162 cable assembly 162 A-D Annexes (TBDs)

Chris DiMinico
MC Communications/PHY-SI LLC/Panduit
cdiminico@ieee.org

- **Proposals for 162 cable assembly and 162 Annexes A-D TBDs**
- **Changes to MTF IL and RL limits**

162.11.4 Cable Assembly DC RL

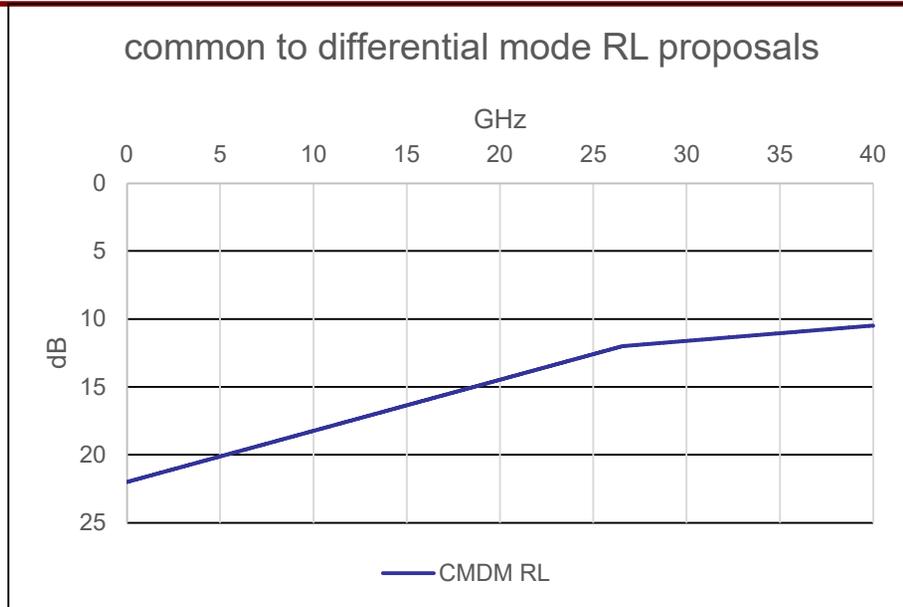
$CDRL(f) \geq$
 $22 - 10 \cdot f / 26.56, 0.05 \leq f \leq 26.56$
 $15 - 3 \cdot f / 26.56, 26.56 < f \leq 40$
 Where

162.11.5 Cable Assembly CDCL

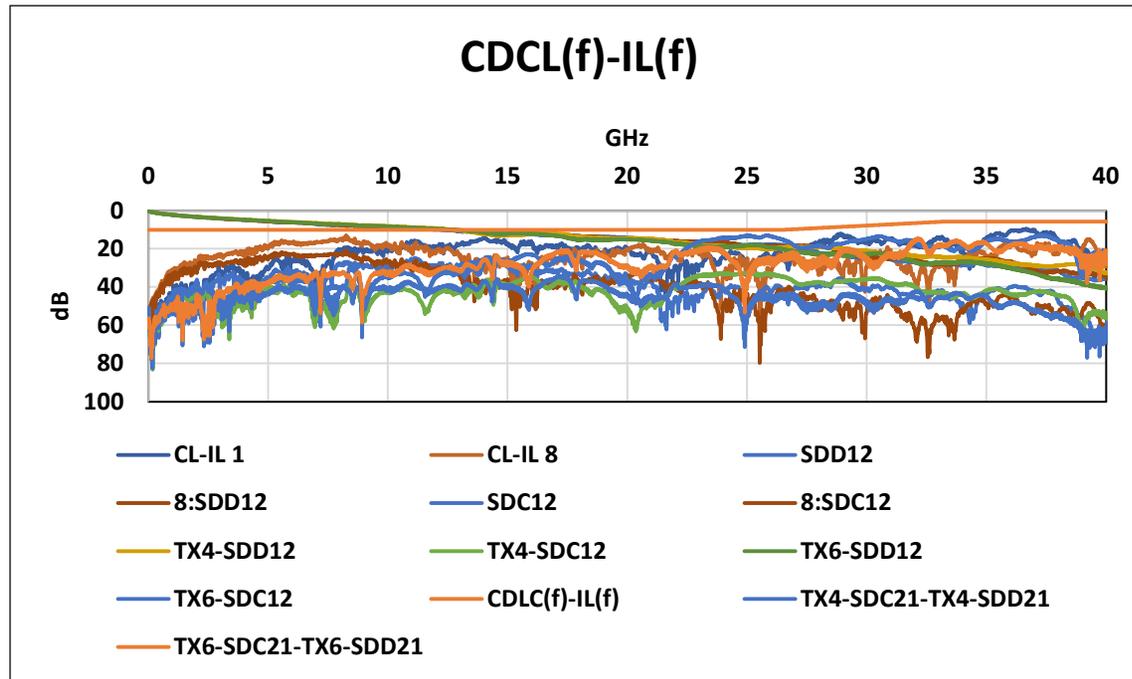
162.11.5 Cable assembly differential to common-mode conversion loss

The difference between the cable assembly differential to common-mode conversion loss and the cable assembly insertion loss shall meet Equation (162-new).

$CDCL(f) - IL(f) \geq$

10, $0.05 \leq f \leq 26.56$

$27 - 17 * f / 26.56$, $26 < f \leq 33.2$

5.75, $33.2 < f \leq 40$

162B.1.3.1 Mated test fixtures differential insertion loss

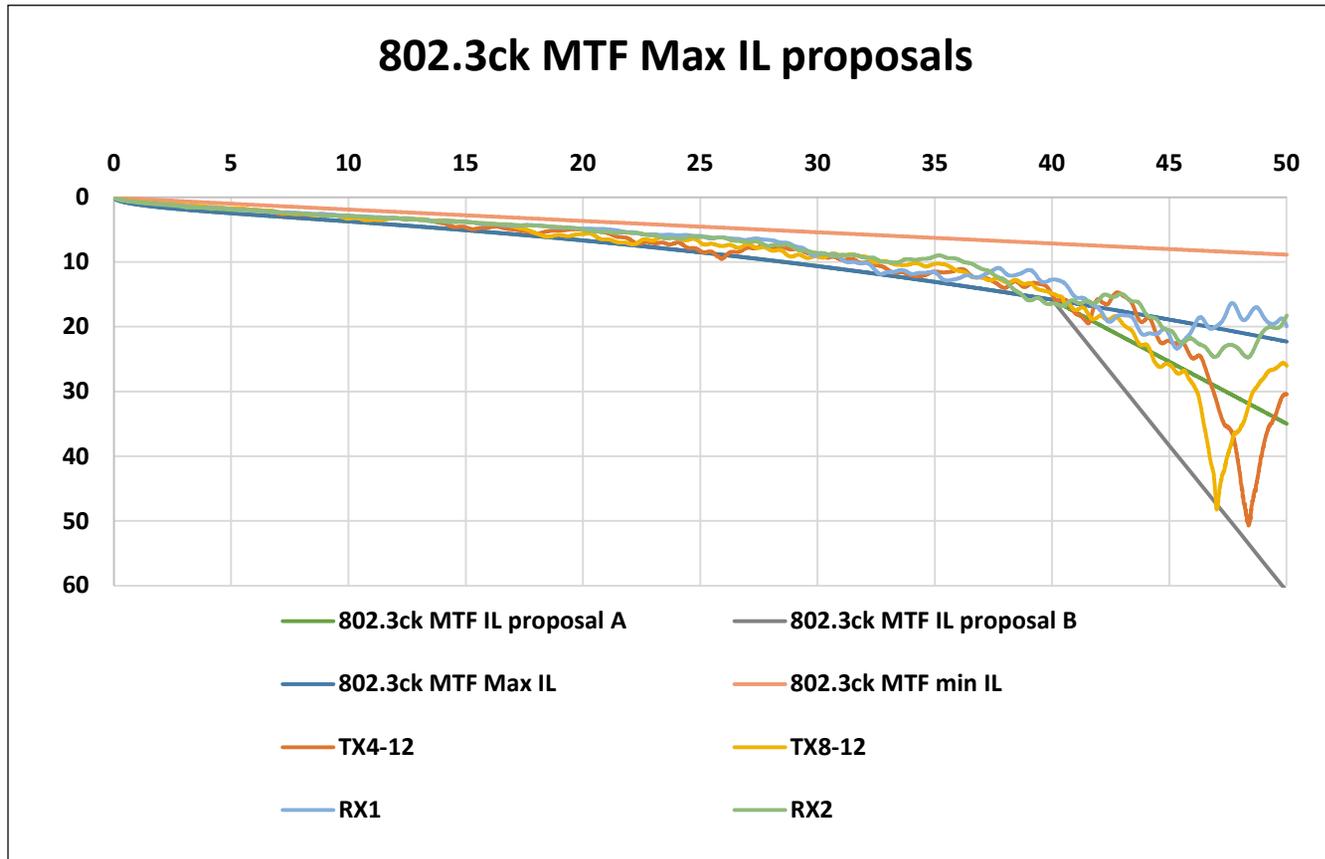
$\text{MTF IL proposal A} = 1.185 \cdot \sqrt{f} - 0.072 \cdot f + 0.007 \cdot f^2$ $0.01 \text{ GHz} \leq f < 40 \text{ GHz}$
 $\text{MTF IL proposal A} = 1.915 \cdot f - 60.78$ $40 \text{ GHz} \leq f \leq 50 \text{ GHz}$

$\text{MTF IL proposal B} = 1.185 \cdot \sqrt{f} - 0.072 \cdot f + 0.007 \cdot f^2$ $0.01 \text{ GHz} \leq f < 40 \text{ GHz}$
 $\text{MTF IL proposal B} = 4.5 \cdot f - 164.186$ $40 \text{ GHz} \leq f \leq 50 \text{ GHz}$

162B.1.3.2 MTF differential return loss

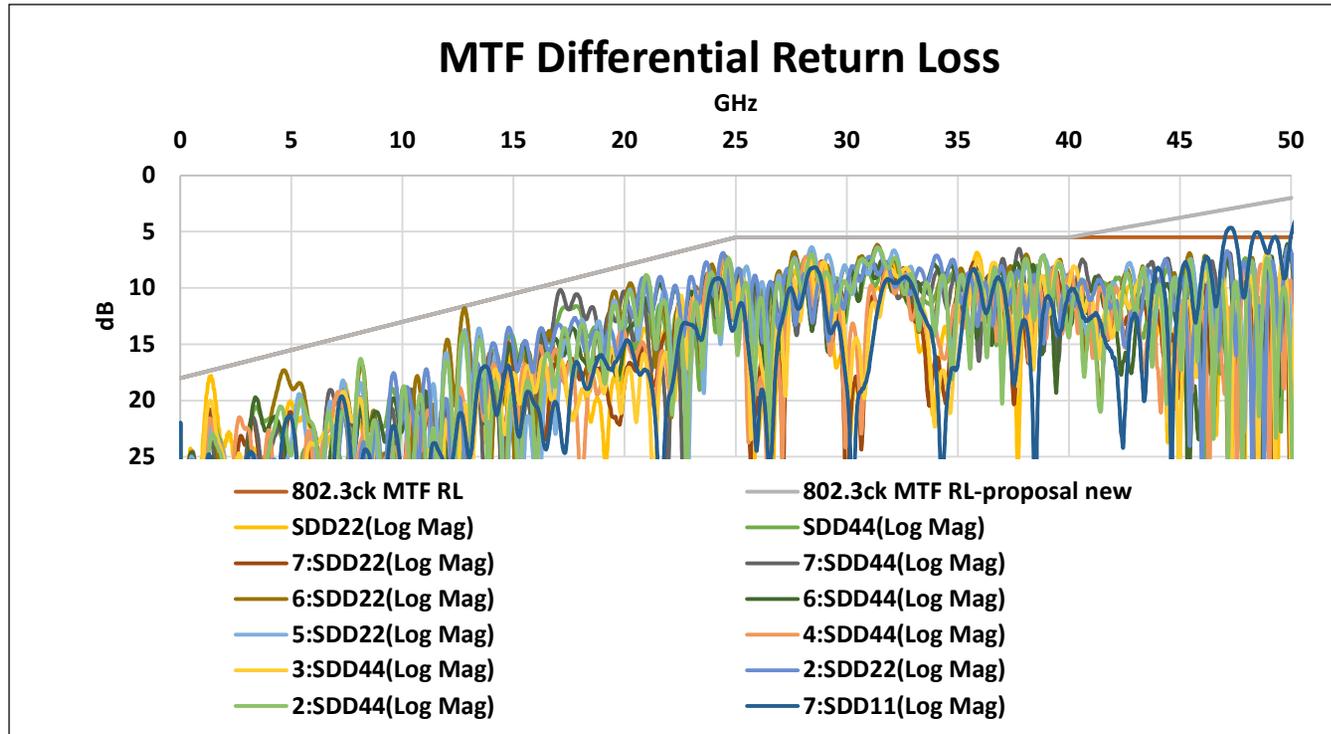
PROPOSAL: Differential Return Loss =

$$18 - 0.5 \cdot f_{\text{GHz}} \quad 0.05 \text{ GHz} \leq f_{\text{GHz}} < 25 \text{ GHz}$$

$$5.5 \quad 25 \text{ GHz} \leq f_{\text{GHz}} < 40 \text{ GHz}$$

$$-3.5 \cdot (f_{\text{GHz}} - 40) + 5.5 \quad 40 \text{ GHz} \leq f_{\text{GHz}} \leq 50 \text{ GHz}$$
